Changing assigned Class through DLL v101

33.2.5.12 Type 3 and Type 4 state diagrams

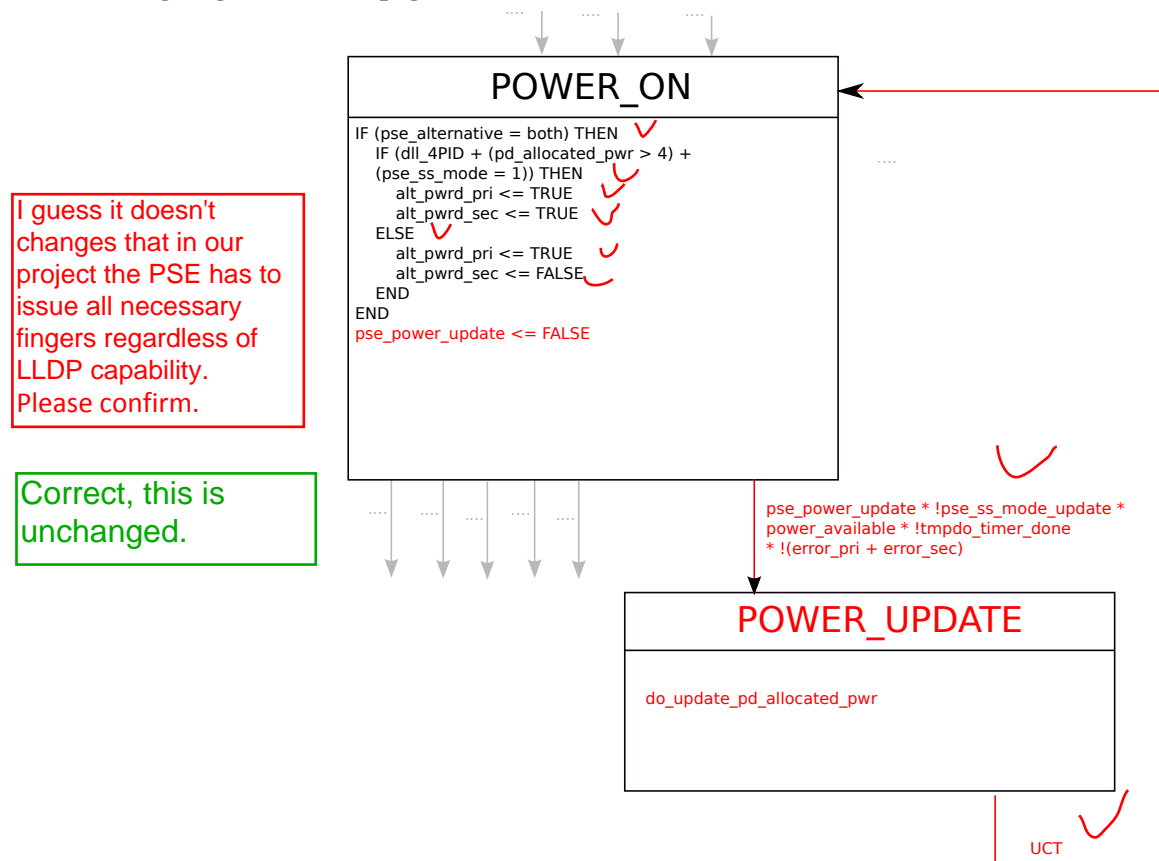
do_update_pd_allocated_pwr

✓ A function that updates the pd_allocated_value based on the value of PSEAllocatedPowerValue as defined in Table 33–14. This function returns the following variable:

Change Figure 33–15 on page 95 as follows:

33.3.3.11 Type 3 and Type 4 single-signature PD state diagrams

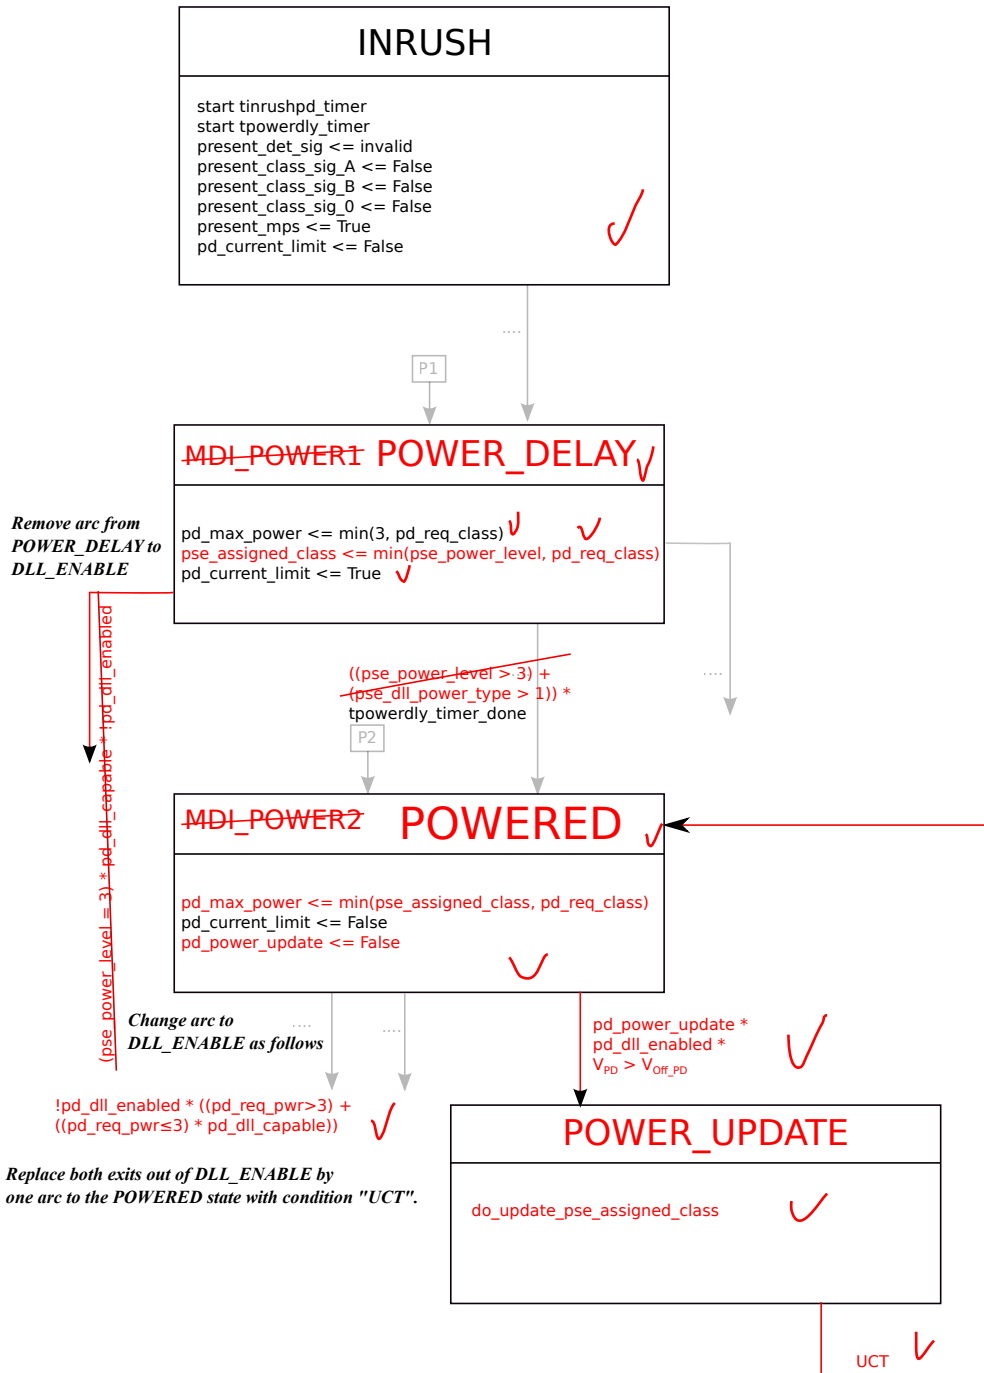
do_update_pse_assigned_class

A function that updates the pse_assigned_class based on the value of PDMaxPowerValue as defined in Table 33–24.

Change Figure 33–32 as follows:
